# HISTORIC PRESERVATION BOARD

---STAFF REPORT---

December 19, 2017

**Midtown Delray (2017-284):** A Class V site plan application for Midtown Delray that includes 39,396 square feet of retail; 11,117 square feet of restaurant; 55,218 square feet of office; 45 dwelling units; and 39 residential-type inn units. The project also includes the relocation of seven of the existing contributing buildings, reconstruction of one existing building, and demolition of two buildings. The relocation of six of the contributing buildings will occur on Block 61 along Swinton Avenue. Another contributing building will be relocated from Block 61 to the Sundry House property.

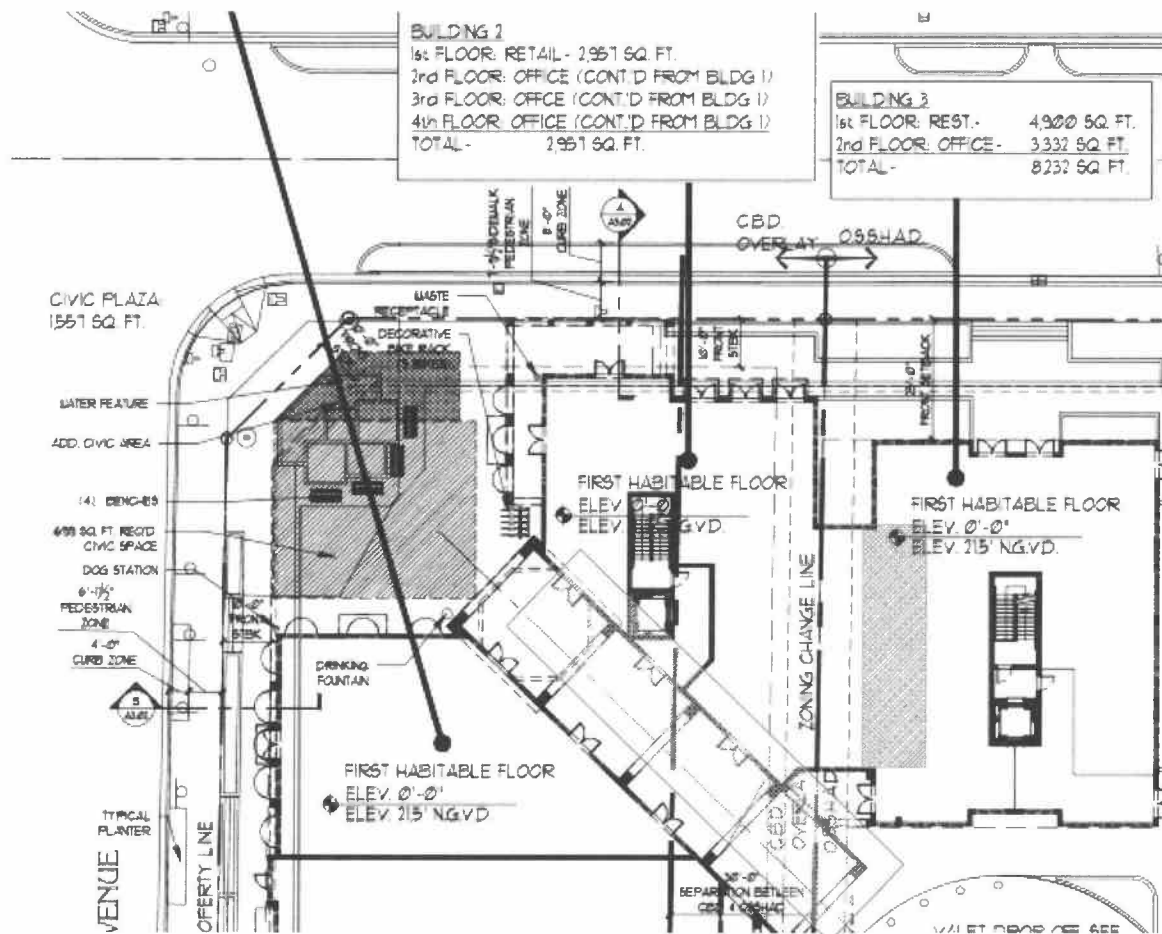
Per LDR Section 4.4.24(F)(4), the maximum width of a building fronting a street shall be limited to 60' and shall have a minimum separation of 15' between buildings fronting a street in a development site that contains more than one structure. The two Residential-type Inn buildings along SW 1<sup>st</sup> Avenue, the Inn building along Swinton Avenue (building #3), and the Inn building at the southeast corner of Swinton Avenue and SE 1<sup>st</sup> Street exceed the 60-foot maximum.

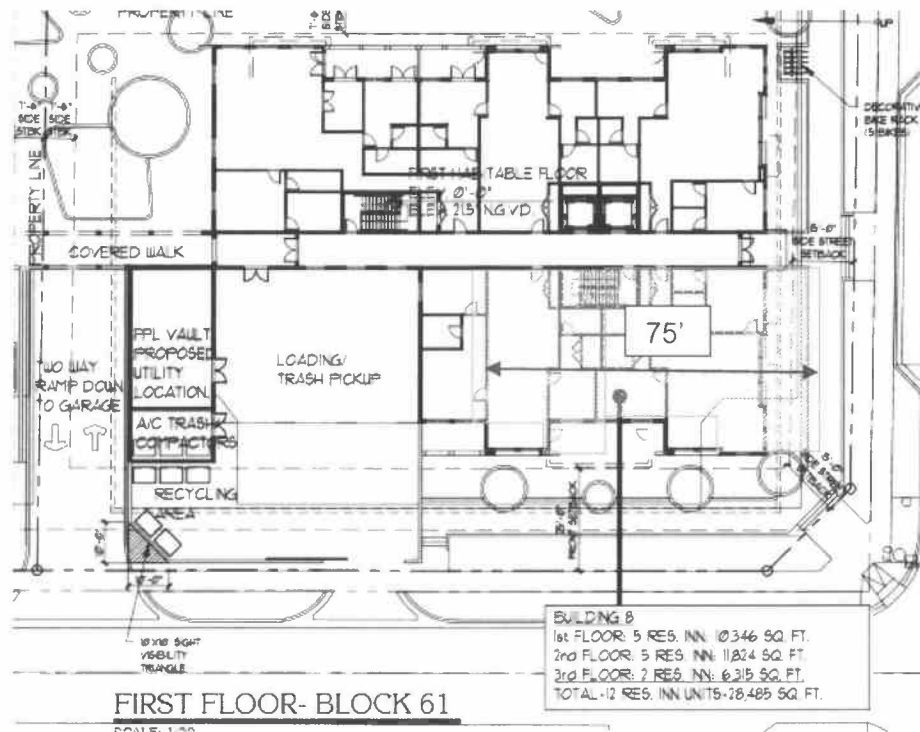
Block 61, Building 8 provides many of the necessary functional aspects of the Midtown Delray Project, which necessitates an additional seventy-six (76) feet in building width along S.W. First Avenue and forty (40) feet along S.W. First Street. Twelve (12) residential inn units comprise Building 8. It also houses a receiving, loading, and air conditioned and acoustically isolated solid waste area that has direct access to SW 1<sup>st</sup> Avenue and whose street frontage consumes fifty (50) feet and three (3) inches. A recycling area consumes an additional twenty-one (21) feet and one (1) inch of street frontage. These project logistics have resulted in a façade that is broken up to reduce the continuous length and relieve the visual length the actual dimension suggests. Similarly, the overhead FPL electric lines that run through the center of the property will be

*reworked to underground facilities, which requires an electrical vault that is shown within Building 8 on Sheet A1.02 of the site plan.*

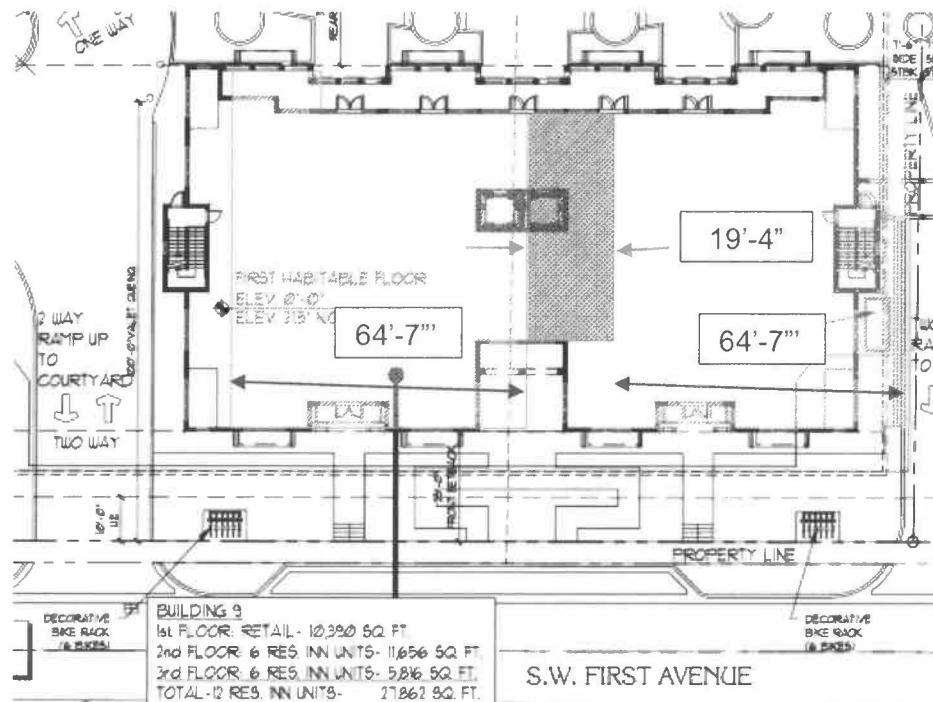
Block 61, Building 9 requires an additional one hundred and four (104) feet in building width in order to provide first floor retail and an additional twelve (12) residential inn units. In order to create a more visual separation in the façade, an additional fifteen (15) foot recess and nearly a twenty (20) foot gap has been added to the middle of Building 9 with landscaping buffers. The main central entry has been eliminated in favor of two entries in the north and south wings. These sixty-five foot wings are connected by the elevator and stairway elements that are stepped back even more on the second and third floors to accommodate upper story planted roofs and a green-wall system. The roof line changes from a sloped roof to a flat roof above the center connection core that further presents the building as two connected facades rather than one long façade.

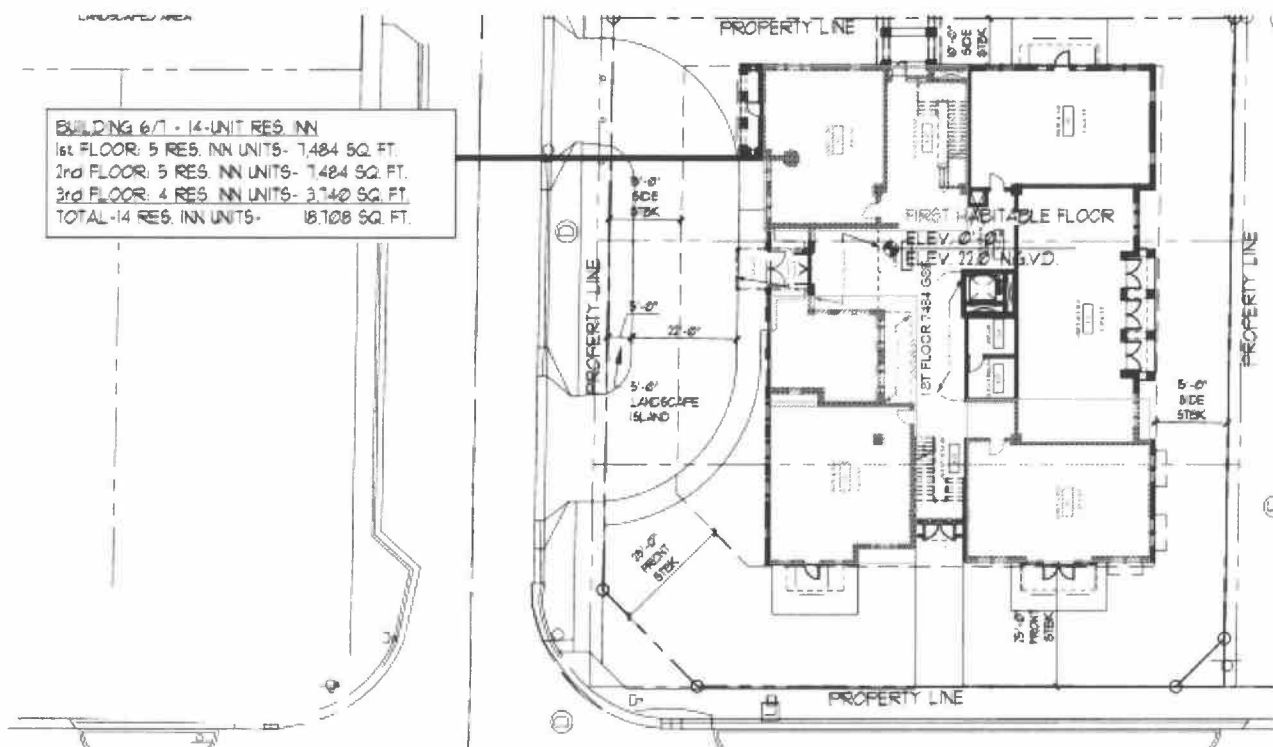
Block 70, Building 6/7 requires an additional forty-four (44) feet and four (4) inches in building width along SE First Street and twenty-one (21) feet and seven (7) inches along South Swinton Avenue in order to accommodate fourteen (14) residential inn units and to integrate the building with the Sundy House. The extension of the overall building beyond the sixty (60) foot façade lengths compensates for the reduction of the permitted three-story building along South Swinton Avenue down to two stories to better transition with the residential along the street and the Sundy House to the west. This is further emphasized with the zoning of the masses separated by the entry facing SE First Street and the stair entry facing South Swinton Avenue.

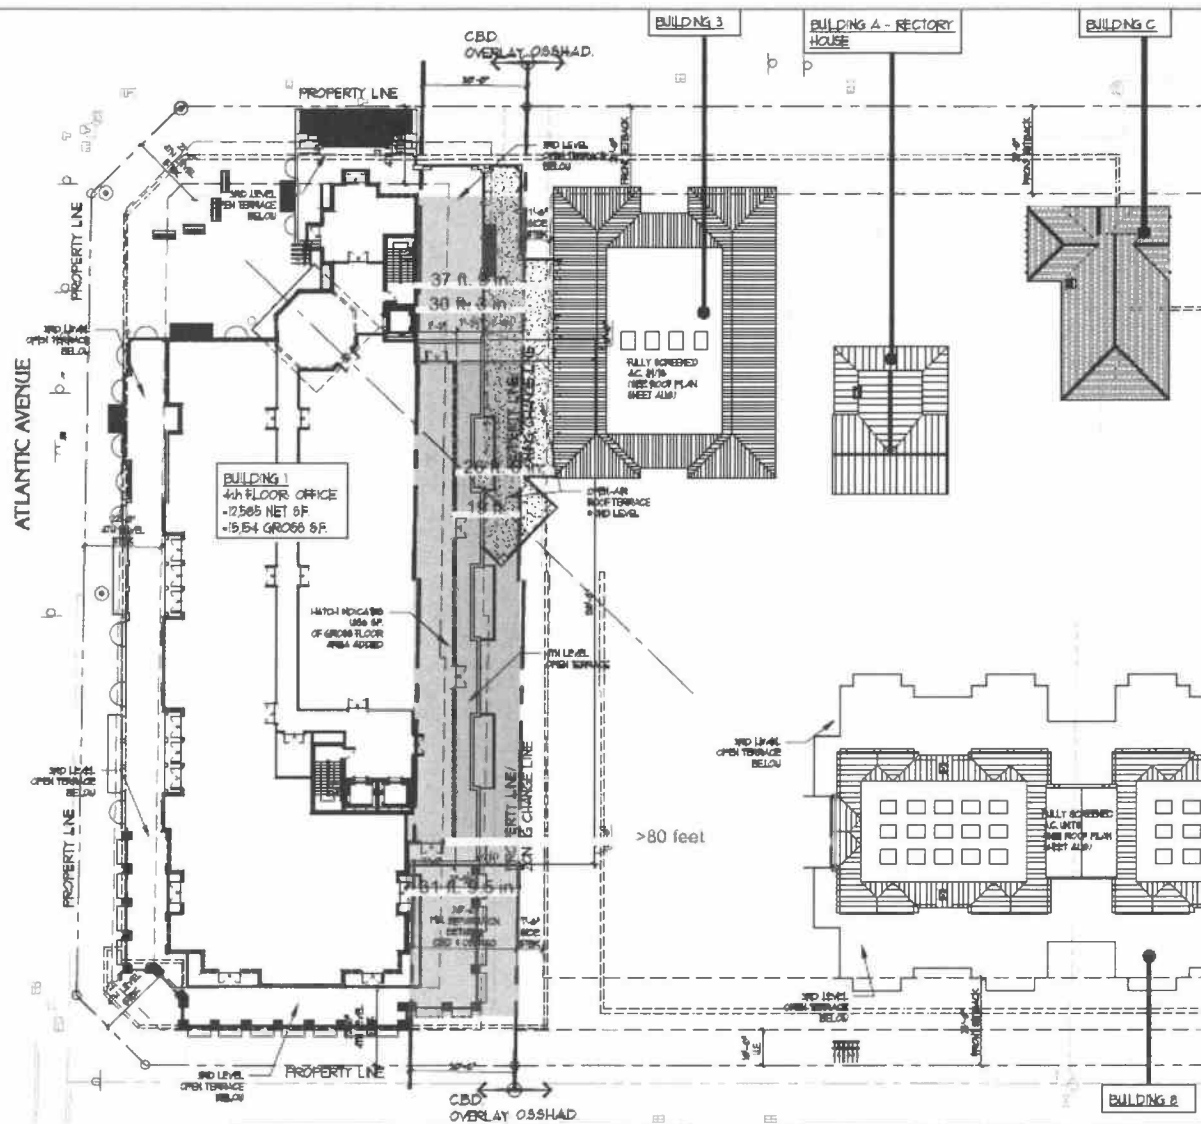
LDR Section 4.6.4(A)(1) is applicable to properties subject to the development standards of the CBD. In this case, Buildings 1 and 2 on Block 61 are subject to the development standards of the CBD and abut an OSSHAD zoned district. LDR Section 4.6.4(A)(1)(a)(ii) requires a minimum thirty (30) foot rear setback if the property abuts a zoning district with a height limitation of thirty-five (35) feet and if the building exceeds three (3) stories in height. Here, Buildings 1 and 2 abut OSSHAD, which limits building heights to thirty-five (35) feet, and Building 1 exceeds three (3) stories in height. Therefore, this code provision requires a thirty (30) foot rear setback for Building 1. Additionally, LDR Section 4.6.4(A)(1)(a)(ii) also provides that the rear setback is measured from the property line to the top of the third story. The Applicant proposes the following: (see illustrations below)

| <u>Block</u> | <u>Building</u> | <u>Minimum Rear Setback Required</u> | <u>Proposed Rear Setback</u>   |
|--------------|-----------------|--------------------------------------|--|
| 61           | 1               | 30 feet                              | 19 feet for a portion of Building 1 from the top of the third floor to the property line only (Approx. 138 feet only)<br><br>The remainder of Building 1 complies with the 30 foot minimum rear setback. |

The intent of this code provision is to create a visual separation between the height differentials of the CBD and OSSHAD zoning districts. The Applicant still meets the intent of the Code despite the proposed waiver request. On the southwest façade of Building 1, there is a significant distance separation (approximately over eighty (80) feet) between Building 1 in CBD and Building 9 in OSSHAD, which achieves the visual separation in excess of the minimum required. On the southeastern portion of the façade, there is a distance separation (approximately thirty-seven (37) feet and nine (9) inches) between Building 1 in CBD and Building 3 in OSSHAD, which also achieves the visual separation in excess of the minimum required. It is also important to note that the areas of Building 1 that do comply with the minimum rear setback are also the areas that are most visible from the adjacent right-of-ways. Therefore, the maximum amount of visual separation is achieved if the requested waiver is granted. Finally, the requested waiver is the minimum necessary to achieve the best site design and reasonable use of the property while balancing the interests of the community. As such, the Applicant respectfully requests that the waiver be granted because the proposed site design still meets the intent of this code provision.
